# UNITED STATES PATENT AND TRADEMARK OFFICE

APPLICATION NO.	FILING DATE	FIRST NAMED INVENTOR	ATTORNEY DOCKET NO.	CONFIRMATION NO.
10/633,958	08/04/2003	Hye Suk Chi	RPS920030032US1	5183
47052	7590	12/04/2006	EXAMINER	FERGUSON, MARISSA L

<b>Office Action Summary</b>	Application No.	Applicant(s)
	10/633,958	CHI ET AL.
	Examiner	Art Unit
	Marissa L. Ferguson-Samreth	2854

## DETAILED ACTION

Fig. 3

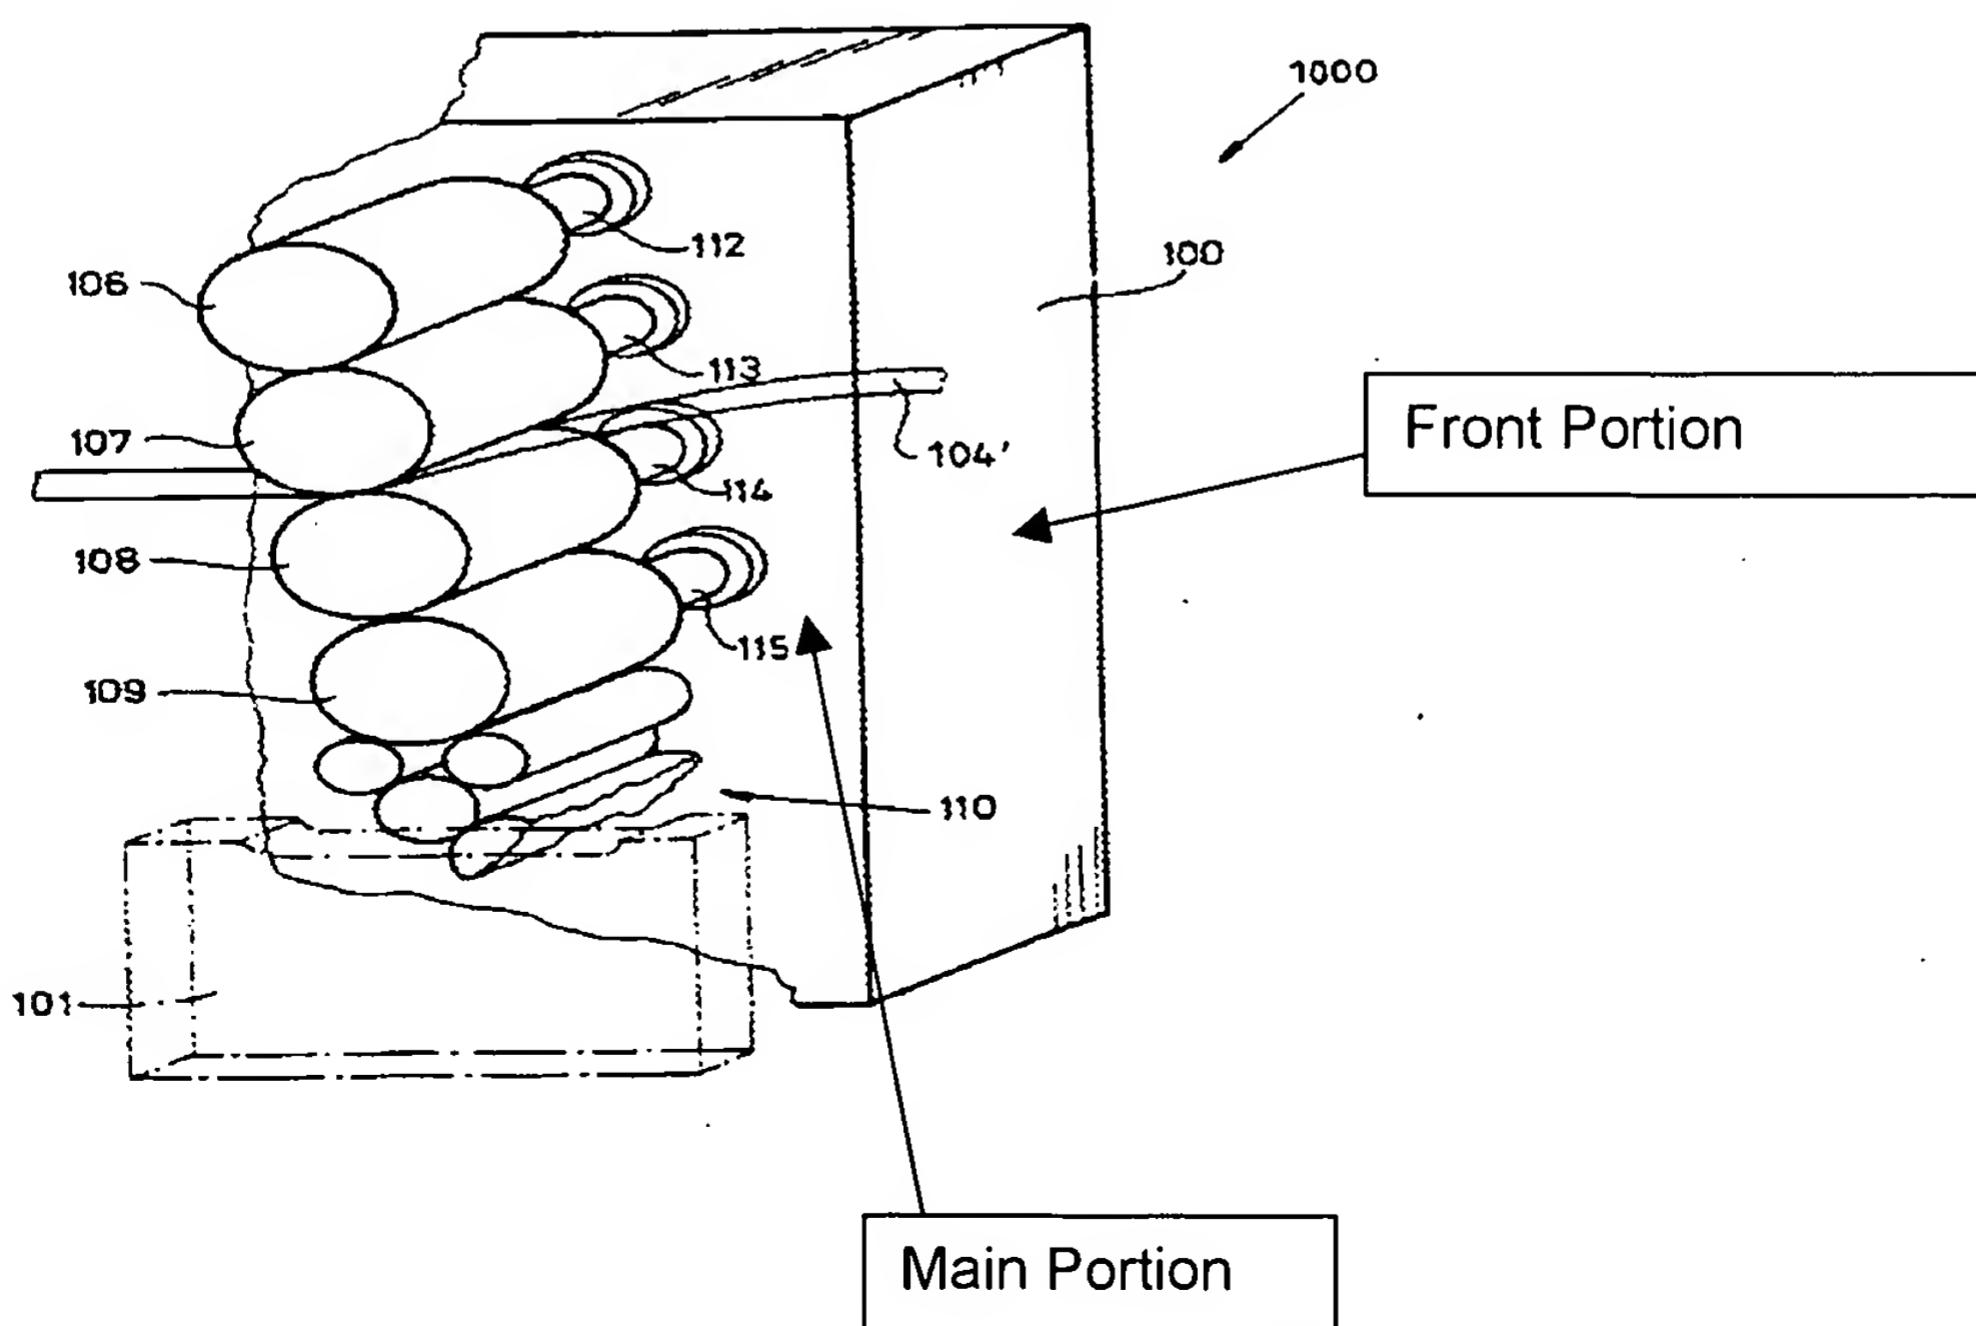
Regarding claims 2, 3, 11, 12, 21, 22, Guaraldi teaches a method and apparatus wherein a supported end of the at least one cantilevered roller shaft (113) is supported at two support locations (100, 11) located outside a document path, wherein the document can be appropriately fed (Figure 3 and Figure 6a) and wherein the need for a rigid frame directly supports the unsupported end is eliminated (Figure 3 and 6a).

Regarding claims 4, 13, 23, Guaraldi teaches a method and apparatus wherein a frame (100) further comprises a main portion and front portion (refer to figure 3 below), and wherein the at least one cantilevered roller shaft (113) is coupled to the main portion such that the at least one cantilevered roller shaft does not rely on the front portion for support (Figure 3).

Regarding claims 6-8, 15-17, 26-28, 35-39 and 43, Guaraldi teaches a method and apparatus comprising a second roller shaft (114) coupled to the frame, a second roller shaft (114) is cantilevered wherein a second unsupported end of the second cantilevered roller shaft floats (Figures 3, 6a) and wherein a second supported end of the second roller shaft is supported two second support locations (100, 111) located outside a document path.

Regarding claims 18, 29, 44 and 45, Guaraldi teaches a method and apparatus comprising wherein a frame (100) further comprises a main portion and front portion (refer to figure 3 on page 3 of the office action), and wherein the second roller shaft (114) is coupled to the main portion such that the second roller shaft does not rely on the front portion for support (Figure 3).
